MINUTES OF HORSMONDEN PARISH COUNCIL
PLANNING COMMITTEE MEETING
HELD AT HORSMONDEN VILLAGE HALL
ON TUESDAY, 20 FEBRUARY 2024 AT 7:00PM

Planning Application No. 24/00078/HYBRID: Hybrid application: Full application for the erection of 120 No. dwellings (Use Class C3), including affordable housing, landscaping, public open space, allotments, ecological enhancements, SUDs and access. Outline application (with all matters reserved) for 0.25 hectares of land for a new Medical Centre (Use Class E(e)) with associated access, parking and landscaping. | Bassetts Farm Goudhurst Road Horsmonden Tonbridge Kent TN12 8AS

Figure 1: Map showing the adopted Limits to Built Development (source: HNP, 2023)

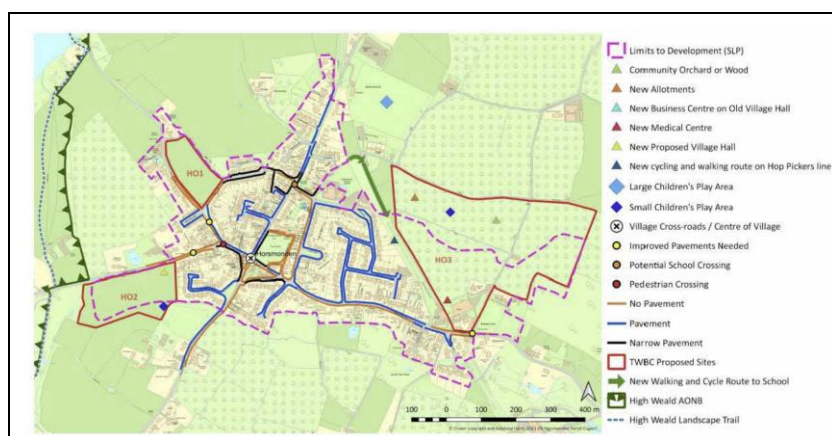
- 1.9. This statement is not wholly accurate. The site is not wholly included within the adopted LBD for Horsmonden. Rather it extends significantly north of the adopted LBD, particularly on the western part of the site.

- 1.10. The adopted LBD is not indicative, as is often referenced by the applicant. It has in fact been established in the HNP, as shown on *Figure 1* (the dotted pink line). It duplicates the LBD as shown in the TWBC SLP, which was informed by a series of evidence reports (see para 1.10) and has been adopted via the HNP in advance of the adoption of the SLP.

- 1.11. This adopted status is confirmed. The LBD was considered at the HNP examination where the extract (*Figure 2*) confirms that it has been defined by the HNP and hence forms part of the adopted development plan.

- 1.3. We would recommend the scheme is reviewed to restrict residential development to within the adopted LBD. This may require a reduction in overall housing numbers as discussed in Section 3 of this response.

Figure 3: Extract from the National Landscape (AONB) (source: AONB Setting Analysis Report, 2020)

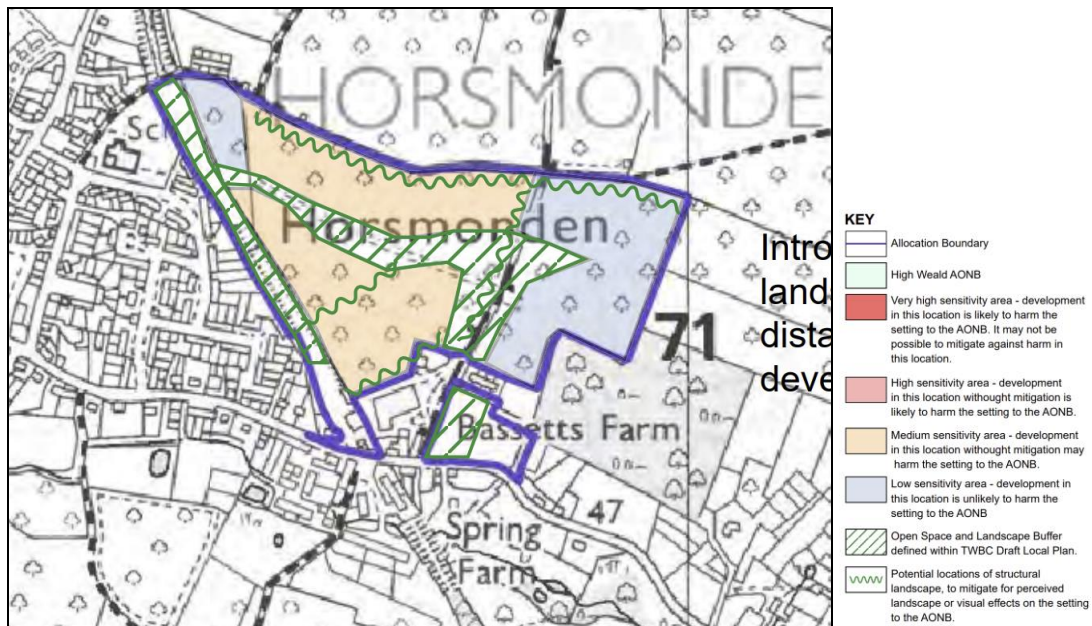
- [AONB Setting Analysis Report: supporting plans and photographs](#) (2020) – The northern areas of the proposed site allocation are considered to have medium sensitivity, meaning that development in this location without mitigation may harm the National Landscape (formally referred to at the AONB). The landscape buffer is shown on these maps (*Figure 3*).

Figure 5: Site allocation map for AL/HO3 (SLP)

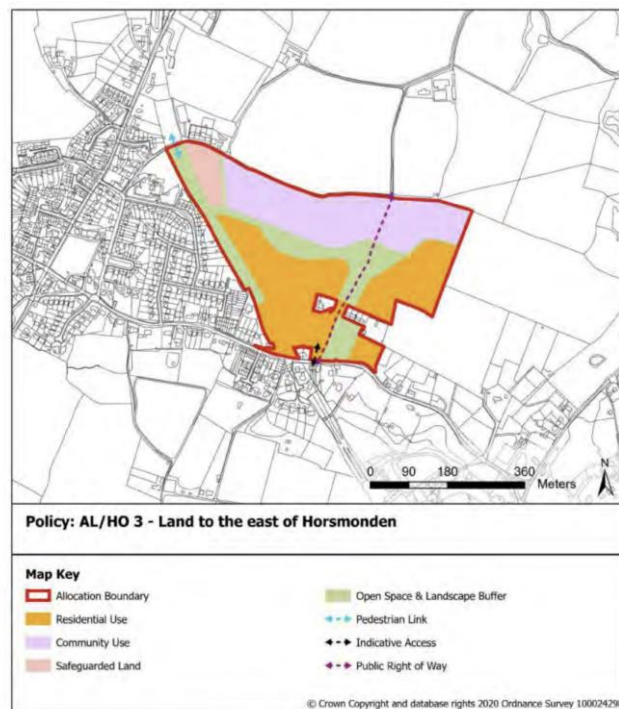
- 2.17. The location of the health centre was discussed at the [Local Plan Examination hearing session for Horsmonden](#) (that can be accessed from 2hrs:35mins) on 5 July 2022. Officers confirmed that its precise location was not finalised and that this would be done through the masterplanning of the site as part of the planning application process. The Inspector agreed with this approach, however, he advised that Policy AL/HO3 should be modified to state that the medical centre will be delivered within

the orange Residential Use area, as shown on the site allocation map (Figure 5) and not within the purple Community Use area.

- 3.8. Moving the medical centre from the purple 'Community Use' area and into the orange 'Residential Use' area, as per the requirements of the site allocation policy and the advice of the Local Plan Inspector, would further reduce the footprint of the application site suitable for built development.

Figure 9: Significant views identified in the HNP (Views 6, 7 and 13)

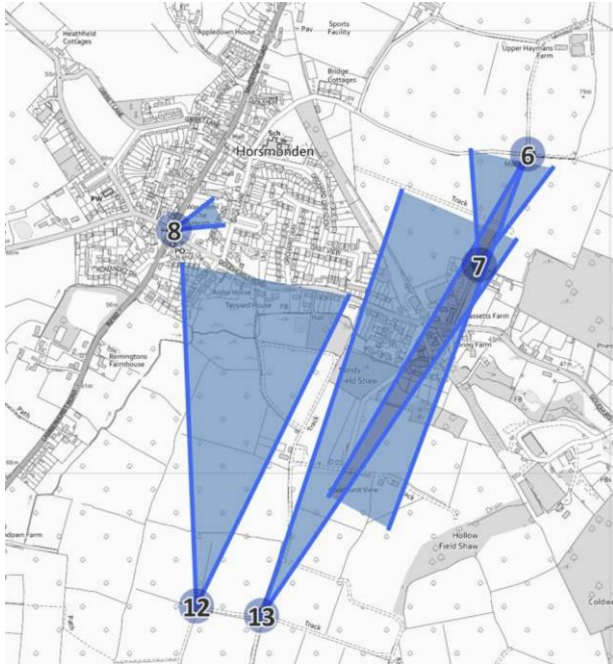
- 5.9. Policy 7.2 of the HNP seeks to protect important local views, stating: *"Development must not cause any loss or diminution of historical or significant view into and out of settlements."* Aside from views onto the site from the High Weald National Landscape, for instance from Goudhurst, three significant views have been identified that need careful consideration within the design of the application (*Figure 9*). Views 6, 7 and 13 in particular include Bassetts Villas non-designated assets) within their scope. The design of the scheme needs to be amended to take account of this.

Figure 10: Image showing area (within the oval area) where landscape buffer should be placed (left), as per SLP site allocation policy (right)

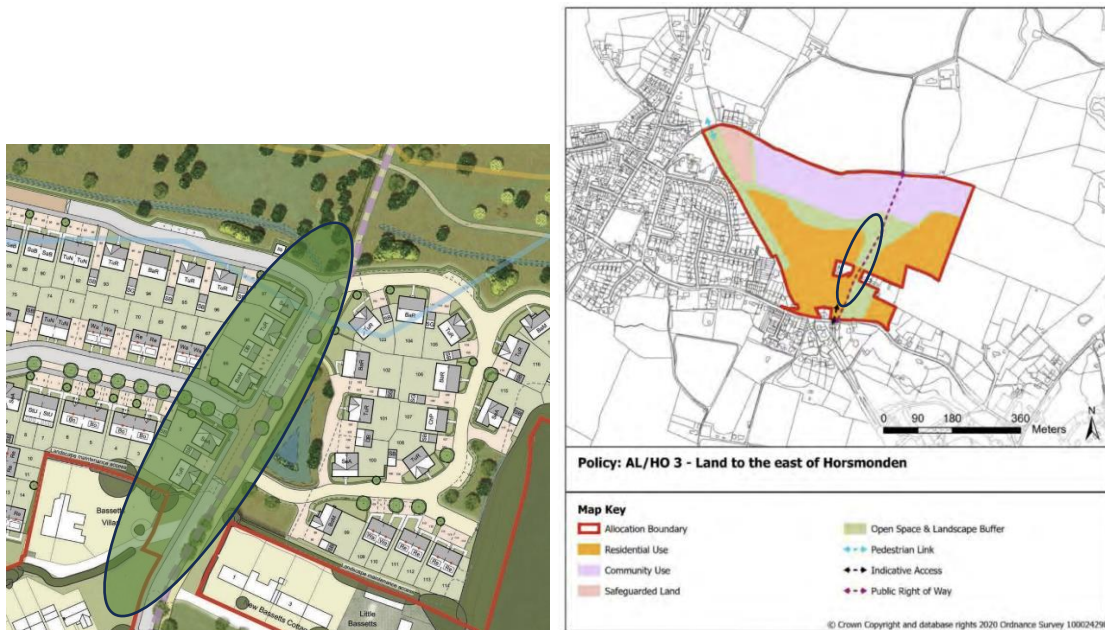
5.10. From a heritage perspective, the proposal seeks to site eight dwellings to the west of the footpath located to the east of Bassetts Villas, which are non-designated heritage assets. This is not in accordance with the site allocation policy in the SLP, which requires a landscape buffer in this location, to the west of the footpath. This is shown on Figure 10. The plans should be amended to incorporate this buffer, which would assist in preserving the setting of those heritage assets.
